Re: St. Lucie Plant Unit 2
Docket No. 50-389
Renewed Facility Operating License No. NPF-16

Response to NRC Request for Additional Information (RAI)
Regarding Extended Power Uprate License Amendment Request

Response to Request for Additional Information

Figure 1:
LNF With Offsite Power Available:
Hot and Cold Leg Temperature vs. Time

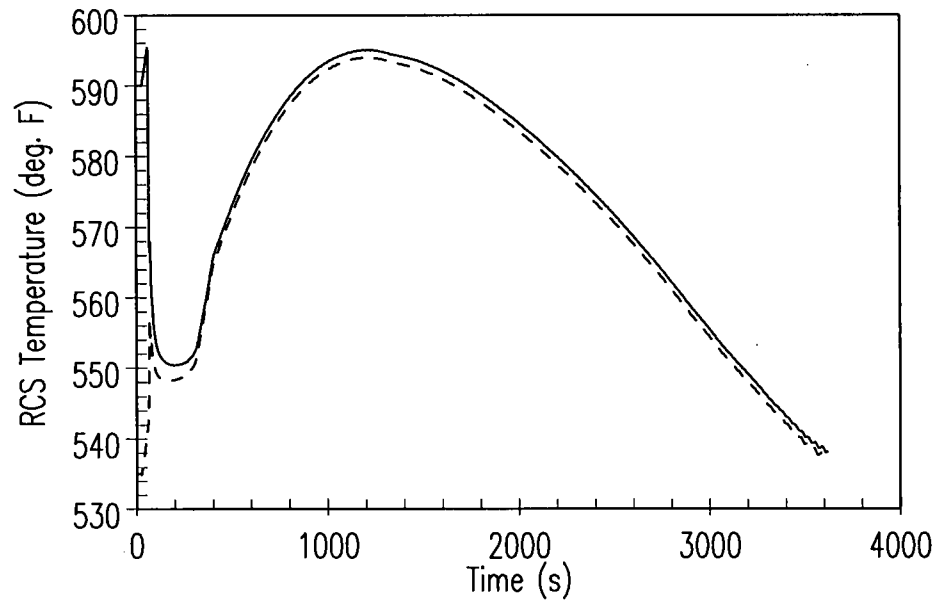
Appendix 10.4.9A, "Auxiliary Feedwater System Requirements Evaluation," to Amendment 19 of the St. Lucie Unit 2 Updated Final Safety Analysis Report (UFSAR), describes that the analysis of the loss of main feedwater with offsite power available was the limiting event with respect to steam generator inventory. The loss of normal feedwater (LNF) analysis discussed in Section 2.5.4.5.2.4, "Results," of the license amendment request (LAR) supporting the extended power uprate (EPU) license amendment request states that the auxiliary feedwater (AFW) system is sized to remove the decay heat and pump heat associated with the event, based on an analysis at nominal plant conditions. However, the results do not directly address the assumptions used in the analysis, the AFW pump flow, and the minimum steam generator inventory determined by the analysis. In addition, the analysis notes that nominal parameter values were used in the analysis.

Provide the assumptions, boundary conditions, and results of the LNF accident analysis. Include the assumed AFW pump flow, the steam generator pressure, the minimum steam generator water inventory, and the basis for concluding the minimum inventory would support continued removal of decay and pump heat. Explain how the use of nominal parameter values in the limiting accident analysis for steam generator inventory would satisfy the design control requirements of Appendix B to 10 CFR Part 50 for operation at EPU conditions.

The LNF analysis performed in accordance with UFSAR Section 10.4.9A shows that greater than 10% of the initial steam generator mass exists in either generator at the end of the transient. The pressurizer water volume remains below 1519 ft³, and as such, the pressurizer does not reach a water solid condition. Pressurizer pressure, despite rising initially, remains below the PSV setpoint and the PSVs do not open during the event. Subcooling margin is maintained throughout the entire event.

The sequence of events for the limiting LNF case (offsite power available) is presented below along with the plots for the RCS temperature (Figure 1) and the SG water inventory (Figure 2). The analysis has been run conservatively for 1 hour with no operator action.

FIGURE SBPB2-1: Manufacturer's Pump Curve For AFW Pumps

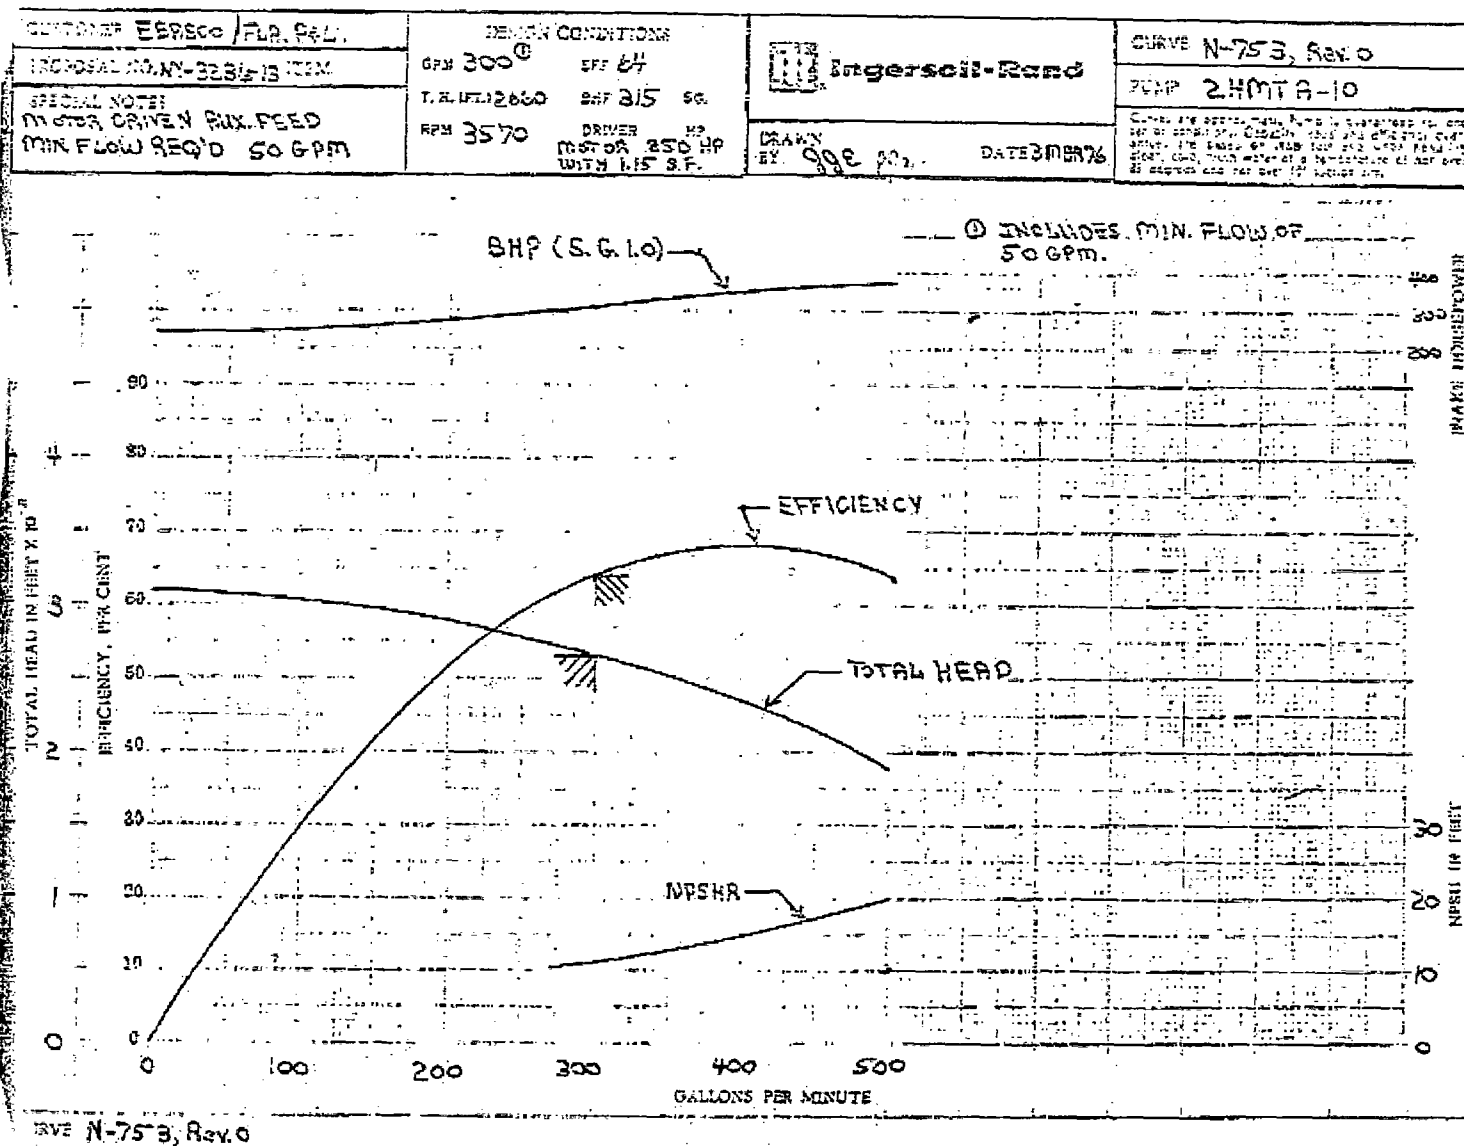
Table 10.4.1, "Component Design Parameters," of Amendment 19 of the St. Lucie Unit 2 UFSAR lists the motor driven AFW pump capacity as 300 gallons per minute (gpm), including minimum recirculation flow of 50 gpm, at a pump head of 2660 feet [~1150 psid]. However, the bases for TS 3/4.7.1.2, which were provided in Attachment 4 to the LAR, specify a delivered flow to the entrance of the steam generators of 320 gpm at 1000psia (MSSV setpoint) for each motor-driven pump. Reconcile these flow values considering the flow head loss at 320 gpm and the elevation difference between the pump discharge and the steam generator water surface. Provide the motor driven AFW pump performance curves and the results of full-flow inservice testing supporting the specified performance.

The capacity of 300 gpm in Table 10.4-1 of the St. Lucie Unit 2 UFSAR is based on the original sizing for the AFW pumps as demonstrated by the manufacturer's pump curve. A St. Lucie calculation, which considers flow head loss and elevation head, demonstrates that using this curve, the motor driven AFW pumps are capable of supplying 320 gpm to the entrance of the steam generators at 1000 psia as stated in the Bases for Technical Specification (TS) 3/4.7.1.2. The EPU accident analysis input for AFW flow is 275 gpm per motor driven pump to a steam generator at 1000 psia.

In-Service full flow performance testing for the motor-driven AFW pumps is provided in plant procedures. These procedures test the pumps at a flow of 246 gpm which, as required by the ASME OM Code, is within $\pm 20\%$ of the 300 gpm flow rate identified in UFSAR Table 10.4-1.

The manufacturer's pump curve and the results of the latest full flow test for each pump are provided in Figures SBPB2-1 through SBPB2-3, respectively.
